ADDENDUM NO. 5

Re: Arch Job Number 24001, DCM #2025238, – Plans Dated: 3/31/25

New Lincoln Police Department

ADDENDUM ITEMS:

C6.1

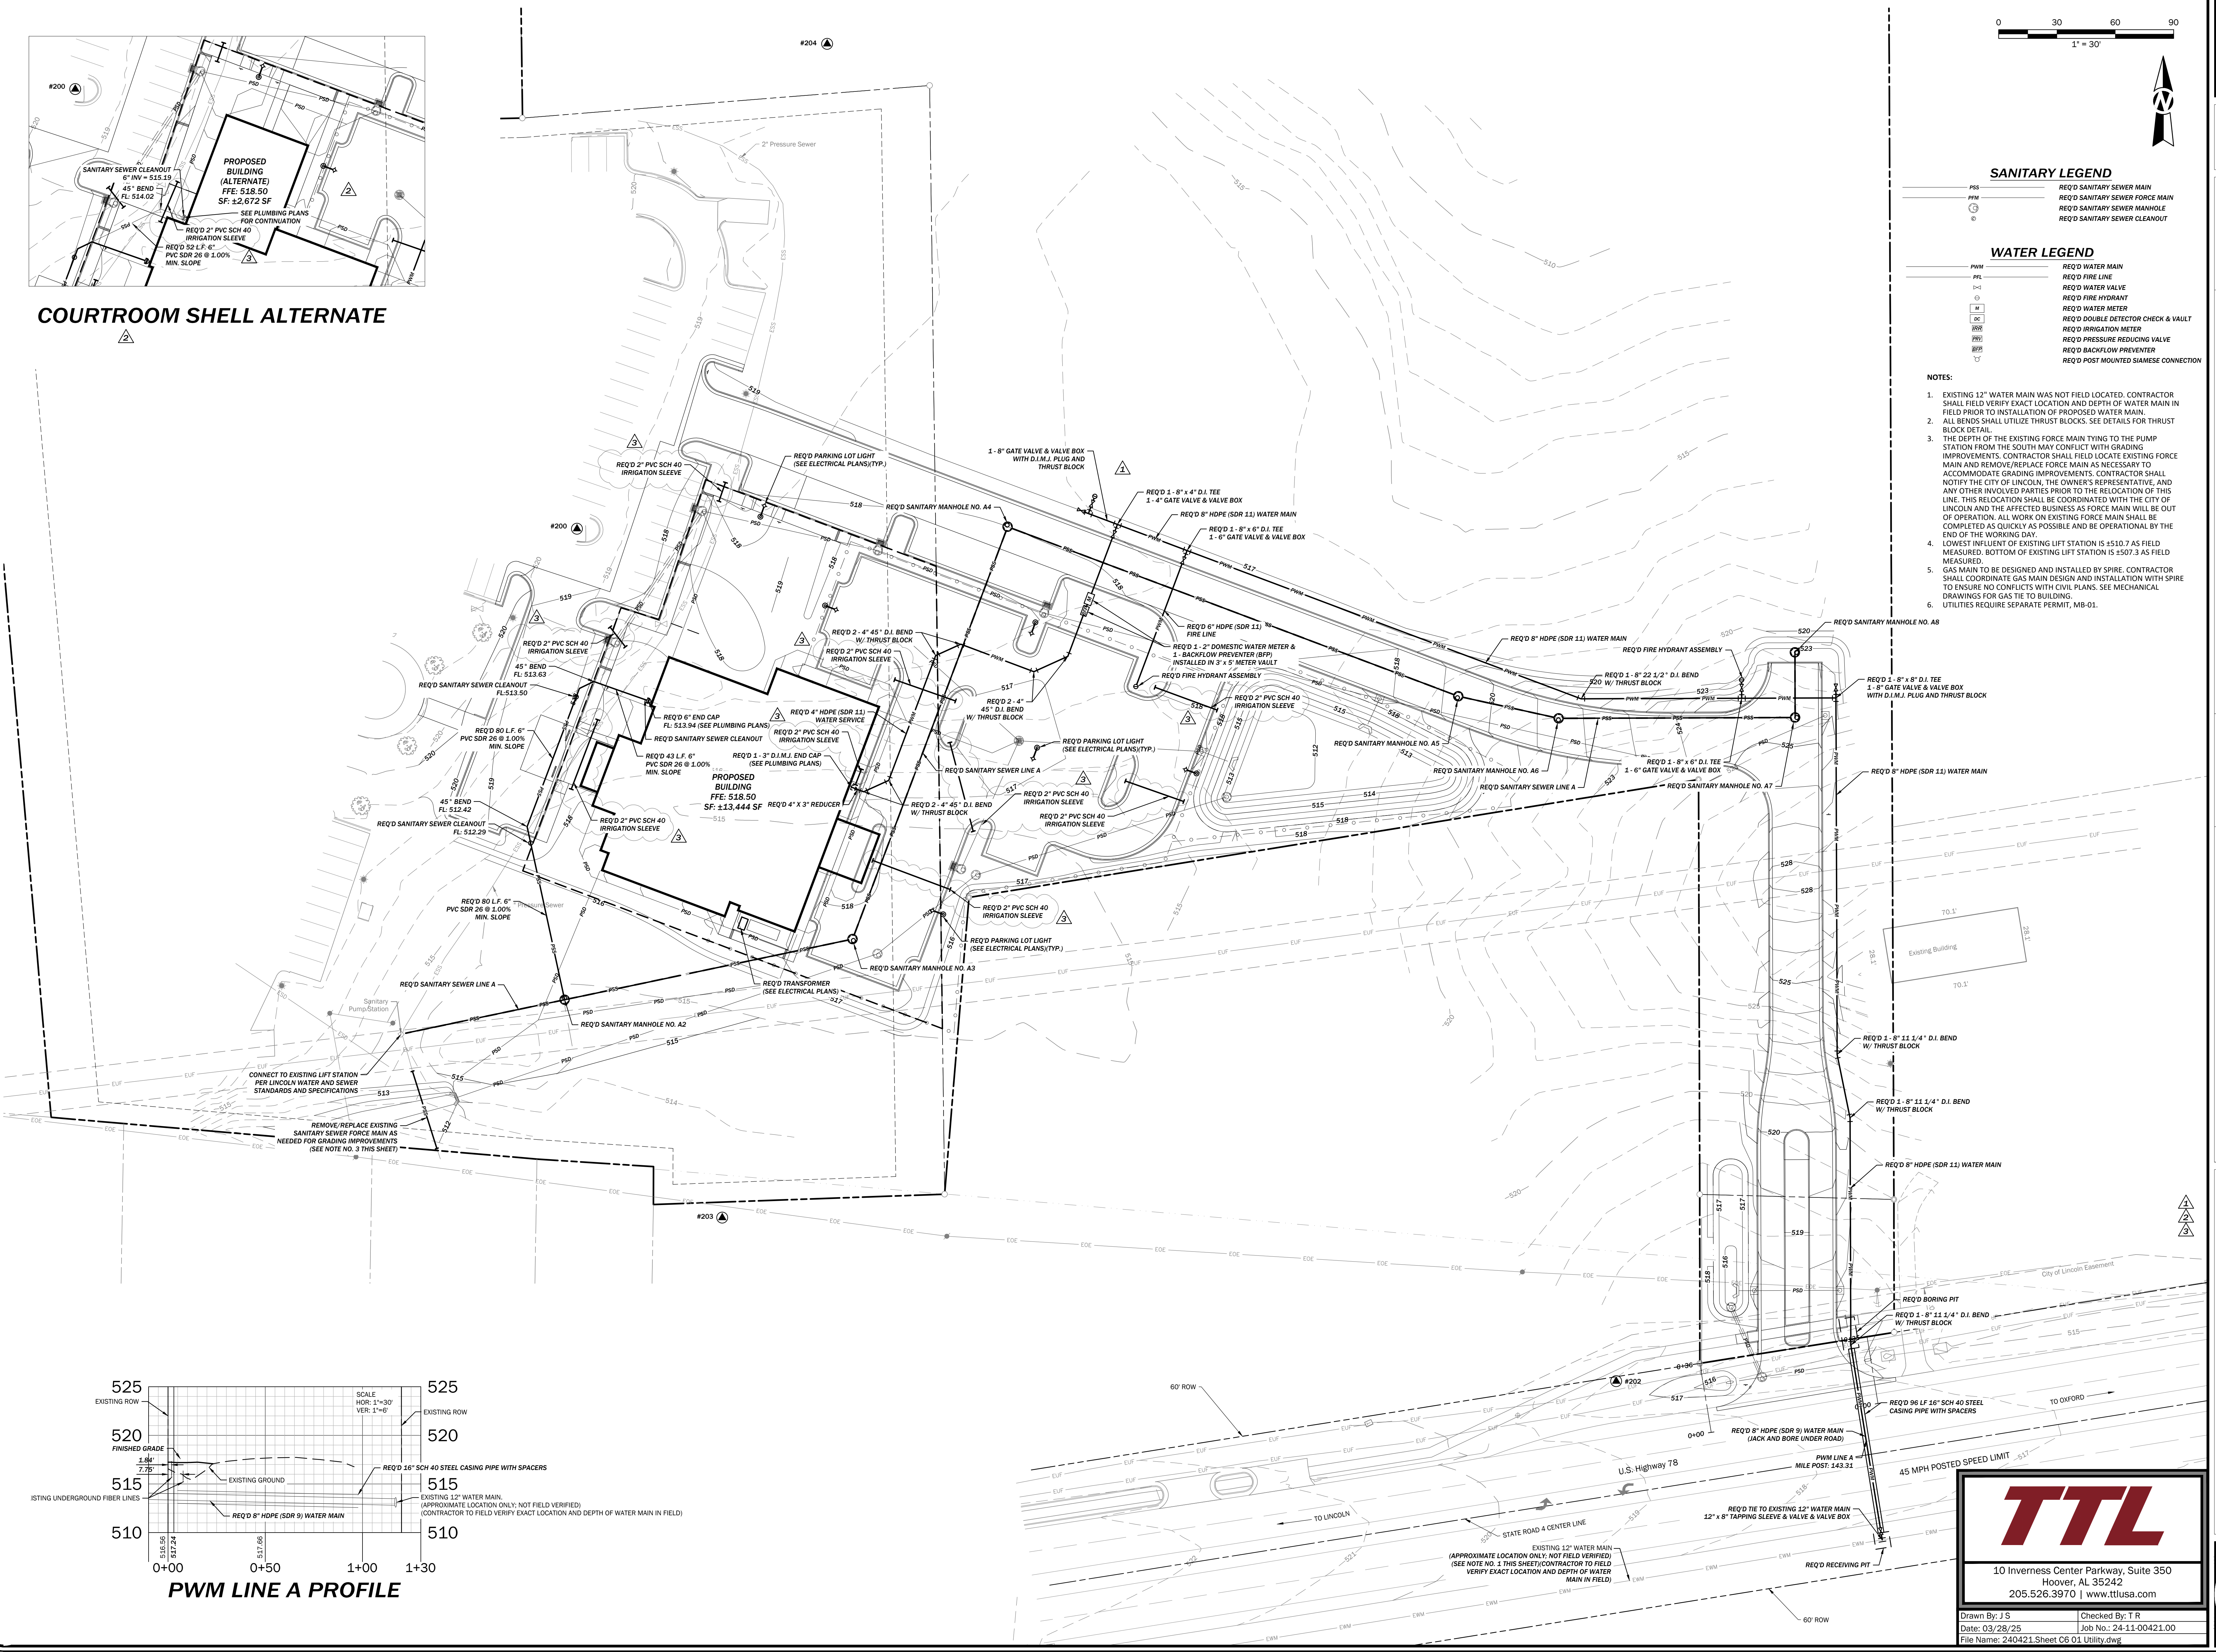
5. Revised Utility Plan has been issued noting irrigation sleeves.
6. Reference Sheet M4.1, Storm Shelter Control / Balancing Damper Notes: Shelter Ventilation Fan Switch shall be located in Mech/ Elec 142. Switch shall be labeled "Emergency Ventilation Switch". Furnish and install storm shelter signage in storm shelter adjacent to HP-13 shelter unit thermostat as follows: "If power loss occurs, switch for emergency ventilation is located in Mech/ Elec 142."

Revised Sheet C6.1 UTILITY PLAN
